Westinghouse  
Electric Corporation

NTD-NRC-94-4257  
DCP/NRC0181  
Docket No.: STN-52-003

SUBJECT: WESTINGHOUSE RESPONSES TO NRC REQUESTS FOR ADDITIONAL  
INFORMATION ON THE AP600

NTD-NRC-94-4257  
ATTACHMENT A  
AP600 RAI RESPONSES  
SUBMITTED AUGUST 8 1994

Figure 2.5-1 Site Qualification Flow Chart

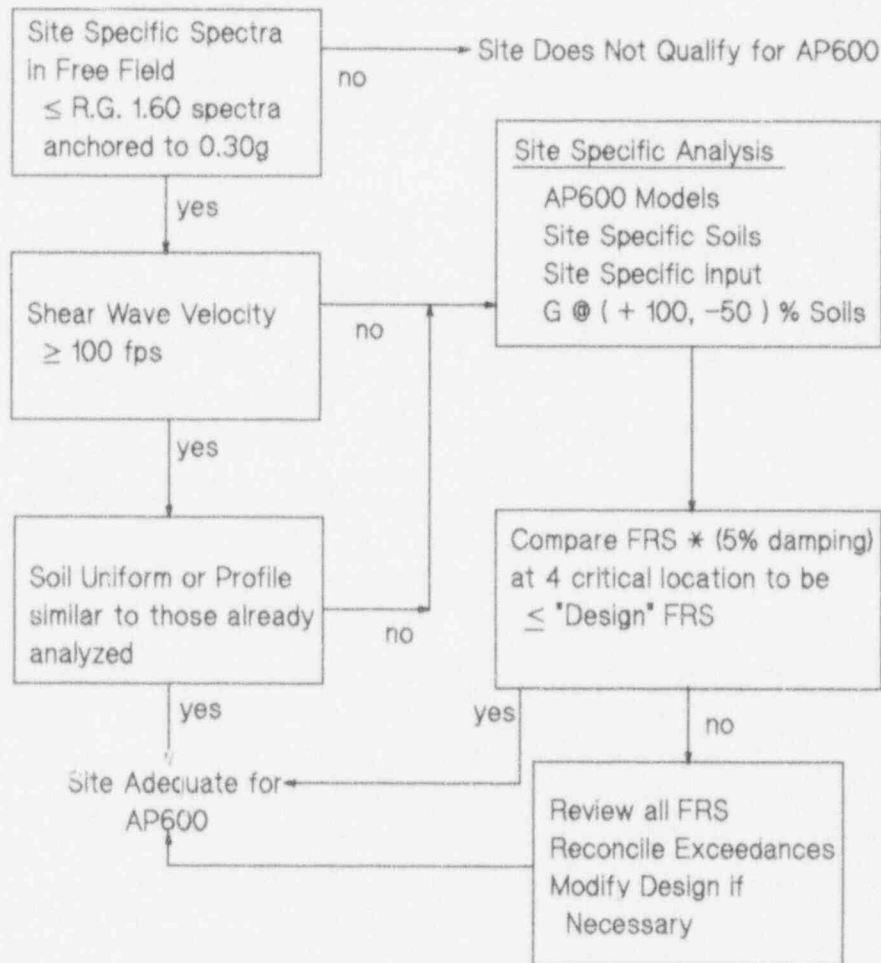
Clarify the following statement in Section 2.5 (p. 2.0-3): "For the site where the soil characteristics differ significantly...site-specific soil structure interaction analyses may be performed to demonstrate acceptability..." Referring to Section 2A.6 of the SSAR in which the base rock depth of design soil profiles was specified at 37 m (120 ft), will site-specific seismic analyses be required if the site base rock depth is, for example, 46 m (150 ft), which is deeper than the 37 m (120 ft) condition analyzed? See staff comment on Section 3.7.1.4 of the SSAR (Q230.10).

Section 2.5 of the SSAR presents the site interface criteria and requirements of potential AP600 plant sites. The site qualification flow chart is shown in Figure 2.5-1, attached to this response.

SSAR Section 2.5 will be revised as follows: Note - this revision was incorporated into SSAR Revision 1

For sites where the soil characteristics are outside the range considered in Appendix 2A.2, site-specific soil structure interaction analyses may be performed by the Combined License applicant to demonstrate acceptability by comparison of floor response spectra at the following locations. Comparison of the floor response spectra at these locations is sufficient demonstration that the site seismic conditions are within the AP600 design basis.

Replace figure 2.5-1 with the attached revision.
